In re: W270CP, Atlanta, GA  
BMPFT-20150427AAD  
Facility ID No. 153804

This refers to the above-captioned minor change application for W270CP.

Overlap attachment:

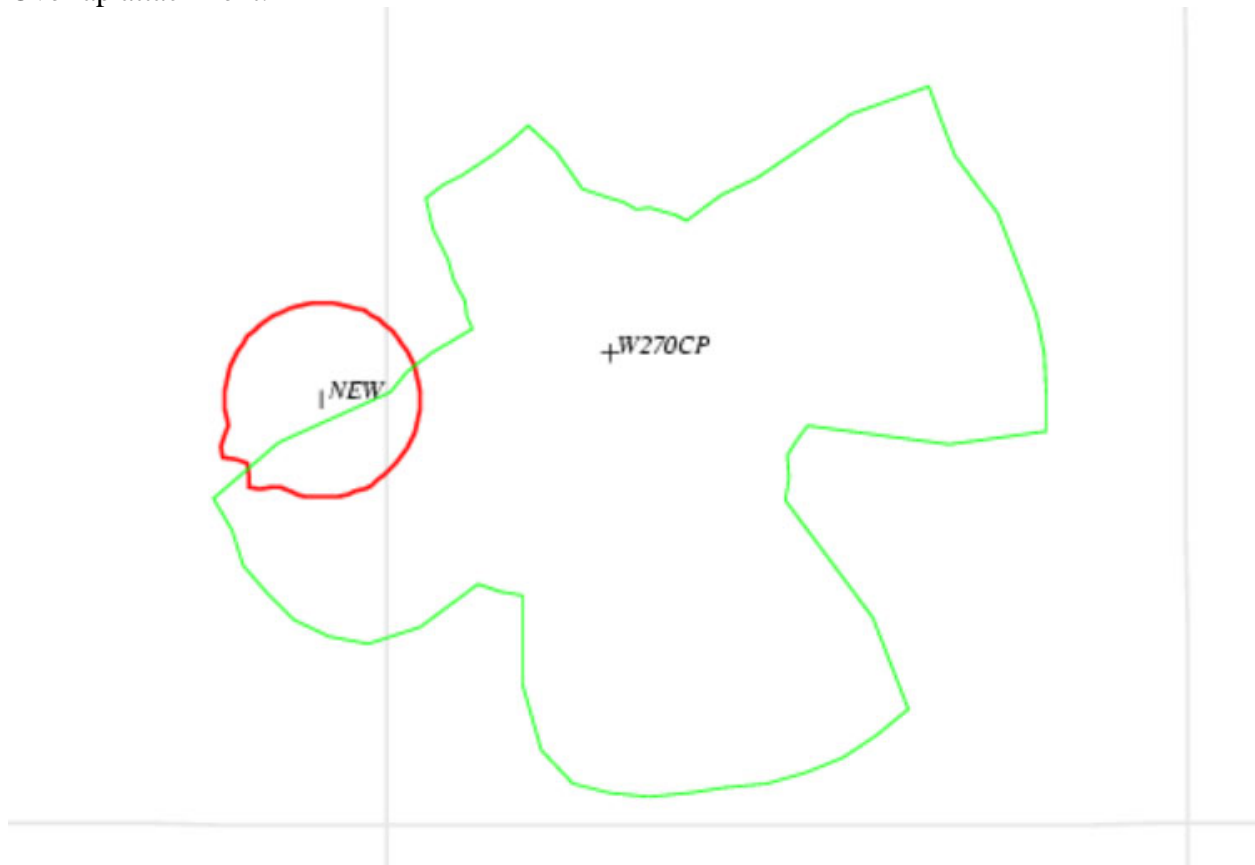
An engineering study reveals the application is in violation of the interference protection requirements of 47 C.F.R. Section 74.1204. Specifically, the proposed 54 dbu interfering contour overlaps the 60 dBu protected contour of the facilities of Low Power FM construction permit BNPL-20131114ALV, Atlanta, GA. The application does not recognize this defect. Accordingly, we dismiss the application as unacceptable for filing.

Red contour: BNPL-20131114ALV 60 dBu protected contour

Green contour: Proposed 54 dBu interfering contour

In light of the above, application BMPFT-20150427AAD is unacceptable for filing pursuant to 47 C.F.R. § 73.3566(a) and IS HEREBY DISMISSED. This action is taken pursuant to 47 C.F.R. § 0.283.
